City of Corpus Christi

Meeting Agenda

Planning Commission

Wednesday, October 28, 2020

Plat of
Mary Carroll High School Tract
Block 1, Lot 1R and Lot 2

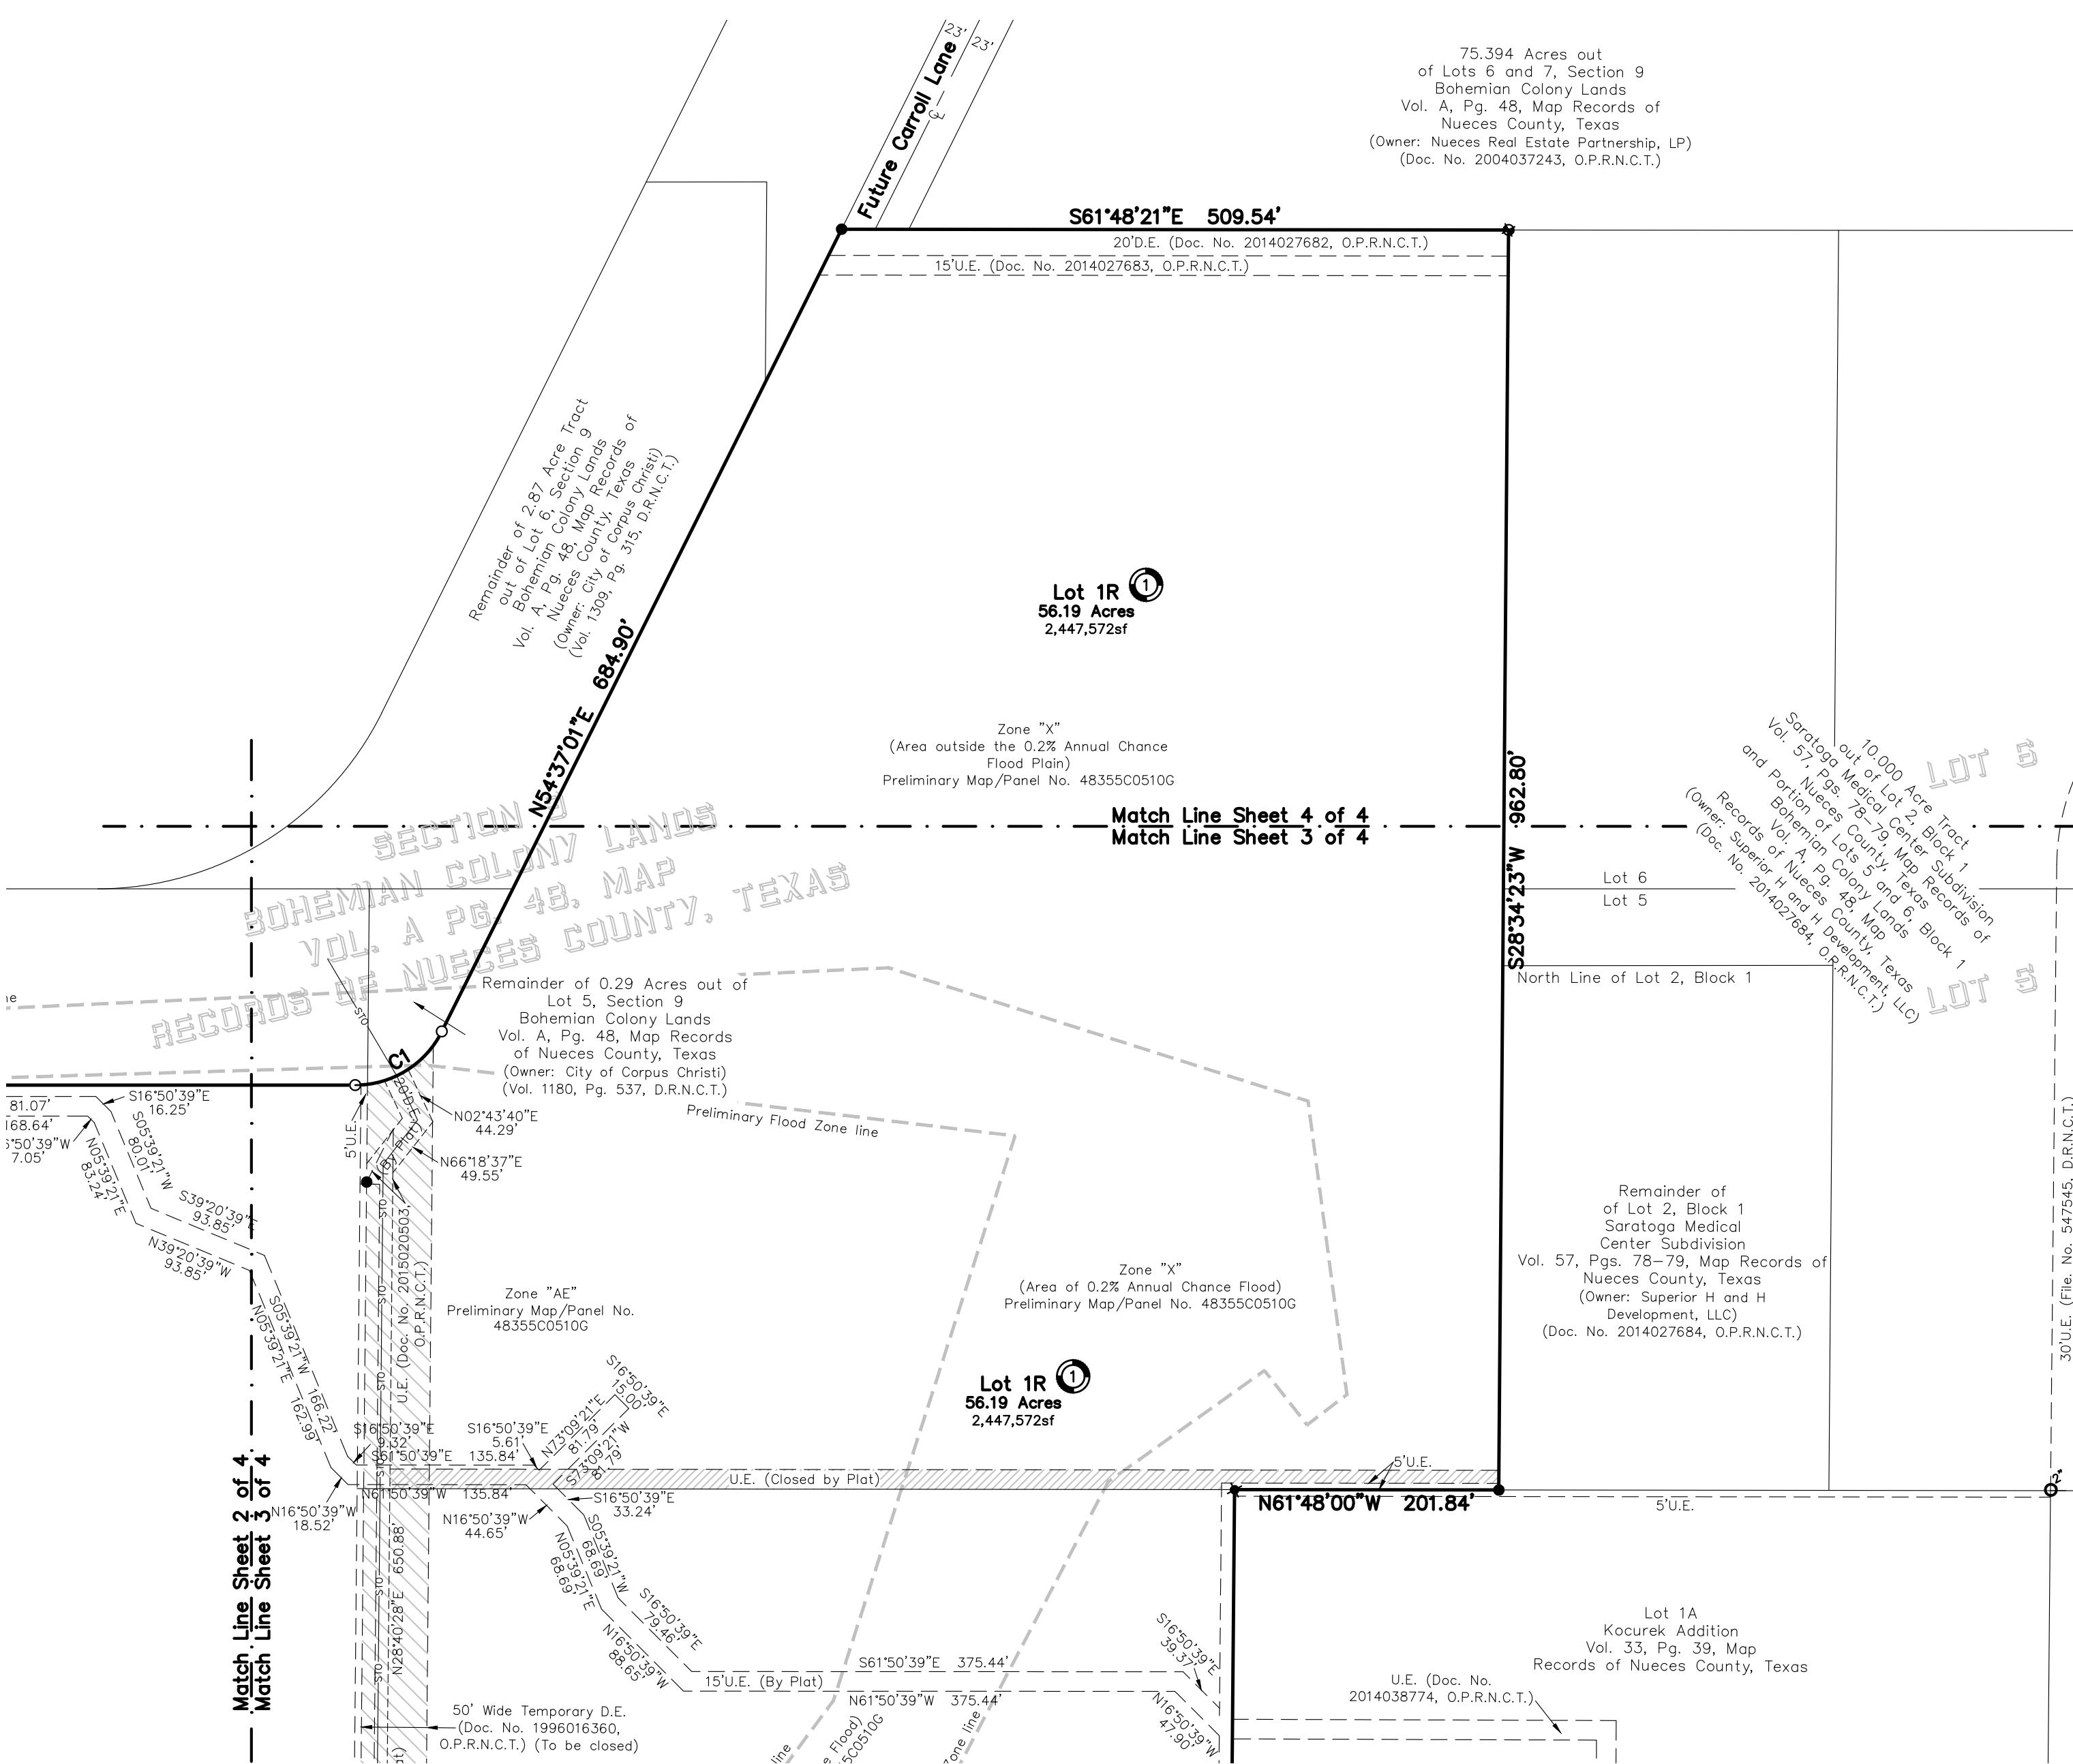
GIS						
No.	Sheet	Comment	Applicant Response	Staff Resolution	Applicant Response	Staff Resolution
1	Plat	The plat closes within acceptable engineering standards.	Understood	Addressed.

LAND DEVELOPMENT						
No.	Sheet	Comment	Applicant Response	Staff Resolution	Applicant Response	Staff Resolution
1	Plat	Provide recorded Deed document numbers for Plat description prior to recording of plat.	Understood	To be addressed prior to recordation.		
2	Plat	Provide access approval by TXDoT for Lot 2 .	Lot 2 is a remainder of an orginal platted lot and will not be owned by CCISD or part of the current development. Access to Saratoga will be permitted through TXDOT by the developer of Lot 2 at time of development.	Addressed.		
3	Plat	Update plat note 10 to include driveway access for Lot 1R.	This is covered in note 9	Addressed.		
4	Plat	Update Planning Commission certificate with Jeremy Baugh as new Planning Commission Chairman.	correction has been made	Addressed.

5 Plat	Add Utility Easement for water line stub for FH near baseball field.	Fire Hydrant will be contained within 15' Easement as shown	Addressed.		
6 Plat	Easement closing on Lot 1R to be approved prior to recording of plat.	Understood			
7 Plat	Provide a plat note indicating that the 50' Wide DE (1996016360) will be closed with plat recording. Construction of new public drainage system within the new dedicated 20' DE will be required prior to plat recording.	note has been added	Addressed.		
8 Plat	Change the 5' UE along the south boundary of Lot 1R to 10' UE for new Public Sanitary Sewer extension.	The 5' UE along the South Boundary of Lot 1R is an existing 5' easement which contains an existing sanitary sewer line which will be extended to serve Lot 2. Enlarging this easement as requested, will result in a private storm inlet falling within a public utility easement. Construction plans for the site have been approved including the location of the private storm.	Addressed.

9 Plat	Show centerline of Future Carroll Lane connection to Lot 1R as per UTP.	future connection has been added to plat	Addressed.

1	Plat	Dedicate additional 5' Right-of-way along Saratoga Blvd for a total of 65' from the Center Line to the Property Line because Saratoga Blvd is classified A3.	we are showing additional 5' dedication where required	Addressed		
2	Plat	Add the following note to the Plat document "Proposed driveway access to Kostoryz Road shall conform to access management standards outlined in Article 7 of the UDC. This includes driveway spacing, driveway widths and corner clearances."	Note has been added	Addressed		
3		Public Improvements Plans are required; submit a pdf copy of proposed public improvements along with a title sheet to PublicImprovements@cctexas.com for review and approval; this item is required prior to Final Plat Recordation. UDC 8.1.3.A	Public Improvement plans were approved on 9-22-2020	Prior to Plat recordation		
4	SWQMP	Provide the Q's for the predevelopment and postdevelopment and the differential for 5 year storm events.	This is on the submitted SWQMP	Addressed

5	SWQMP	The detention calculation provided is for the end results; provide the detail calculations and show how you got to the end results.	Detailed calculations for detention pond is a design matter not a requirement at the platting stage	Addressed
